NOTICE OF A TYPE II DECISION ON A PROPOSAL IN YOUR NEIGHBORHOOD

CASE FILE NUMBER: LU 13-154300 AD

Proposal: The Dannon Company wishes to construct a new vehicle (truck) area and new wastewater treatment system, which includes a building addition and installation of tanks, in

LU 13-154300AD
Exh C.1

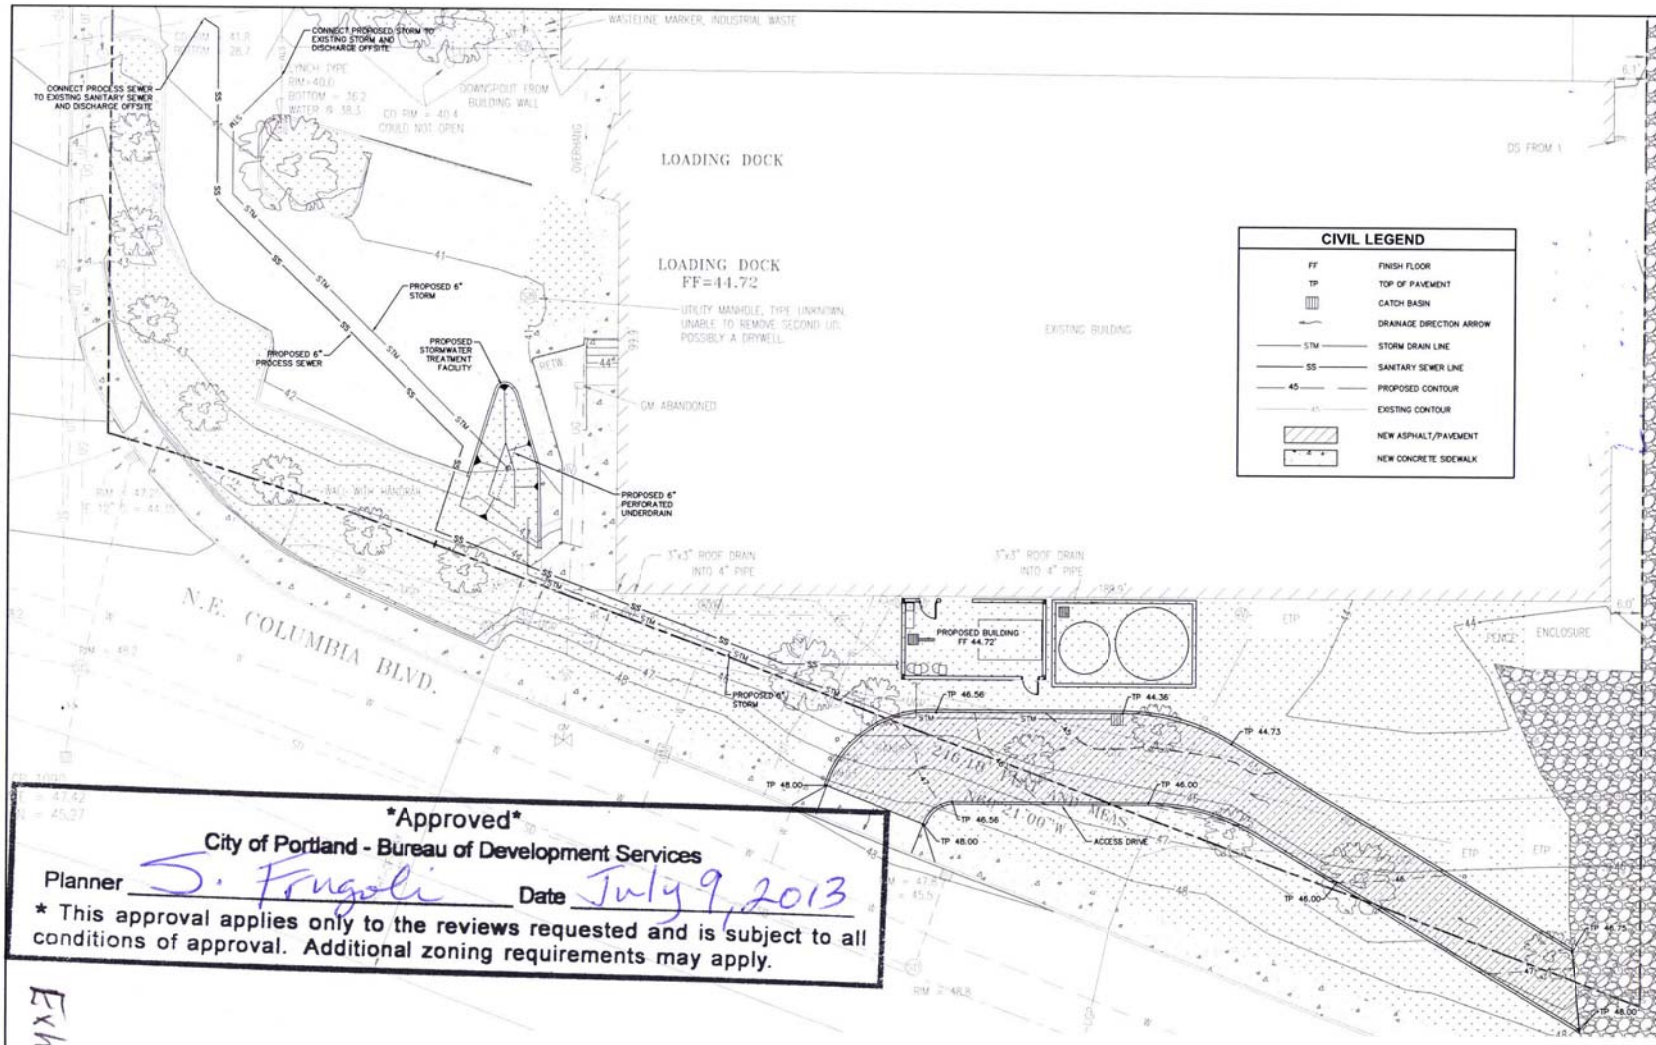
The proposed additions—the metal-clad building and area where holding tanks will be installed, will encompass a 896 square foot area. At its closest point, the southwest corner of the proposed metal building will be located within 8 feet of the south property line. However, the total length of the addition is less than 30 percent of the exiting south facing façade. A portion, approximately 55 lineal feet of the 190-foot south façade already sits within the required 25 foot setback. The southwest corner of the existing building extends within 3.5 feet of the property line. Therefore, the impacts of the proposed addition will not be significant. To lessen the visual impacts of the reduced setback and landscaping and to diminish the prominence of the structures, a condition will require the installation of evergreen shrubs and/or conifer trees along the perimeter of the addition. Further, a condition will require the building and tanks be finished in a color that matches the color of the southern wall of the existing building.

The applicant's submitted plans shows a loss of over 2,000 square feet of landscape area and removal of at least 5 existing trees. The site is currently out of compliance in meeting the required minimum amount of landscaping. The Zoning Code requires 15 percent. Currently the site has 12.6 percent. The proposed addition and vehicle area will reduce the total amount to 10.4 percent; hence moving the site further from conformance. The applicant proposes planting 3 trees and shrubs within the area currently landscaped but within public right-of-way. The additional trees and shrubs would provide visual interest and screening along the edge of the site. However, a land use review, under the authority of the Portland Zoning Code (Title 33), cannot impose requirements off-site. PCC 33.10.030.B states, "Land within public rights-of-way is regulated by Title 17, Public Improvements and not Title 33." If the applicant receives permission from the Portland Bureau of Transportation for proposed improvements within the public right-of-way, they will be granted solely under Title 17 authority.

Approval of an Adjustment to reduce the required overall percentage of landscape on the site from 15 to 10.4 percent (PCC 33.140.225), per the approved plans, Exhibits C.1 and C.2, signed and dated July 9, 2013, subject to the following conditions:

Exh.C.2
LU13-154300AD

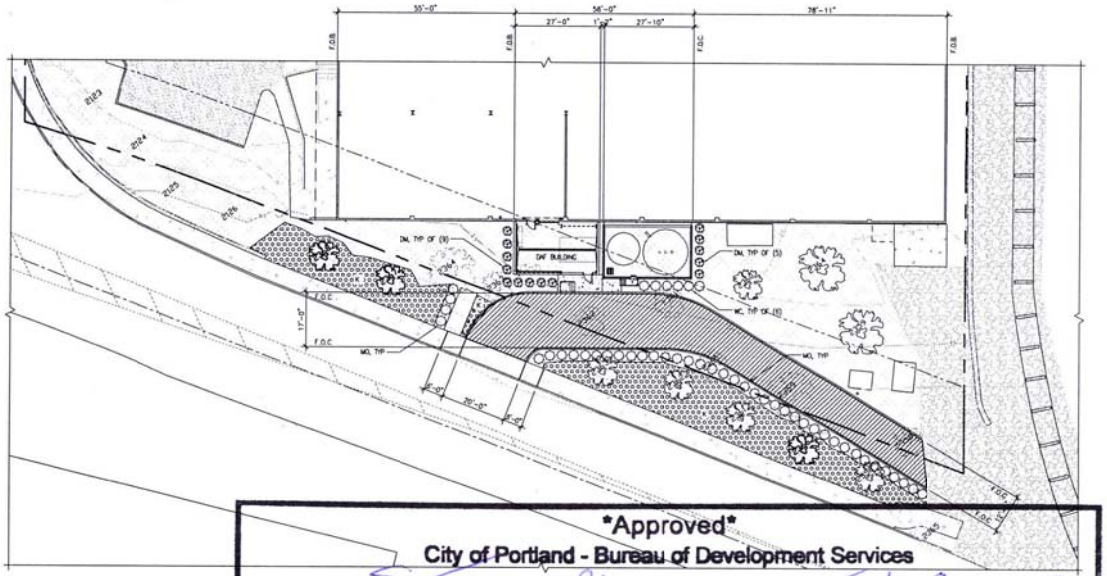
To address the purpose of the Zoning Code development standards, that apply to the site (private property), a condition will require the planting of three deciduous trees and evergreen shrubs on-site, between the south property line and the buildings. As noted above, evergreen shrubs and/or conifer trees along the edge for the building addition and tank facilities will provide visual screening and soften the effects of the development.

B. Evergreen shrubs and/or conifer trees must be installed along the perimeter (west, south and east) side of the proposed building addition and waste tank area, as identified on Exhibit C.2, to create a row of continuous visual screening. The plants must achieve a height of at least 6 feet (L3, High Screen standard) along the perimeter of the building. To facilitate tank disposal onto trucks, the selected shrubs/conifers to be planted between the truck loading area and the tank disposal connection points may be lower in height, to meet the L2 Low-Screen standard).

C. Three new deciduous trees must be installed on-site, between the building and south property line.

D. The building addition, tanks and associated structures and equipment that is visible from NE Columbia Boulevard must be finished in a color that matches the color of the southern wall of the existing building.
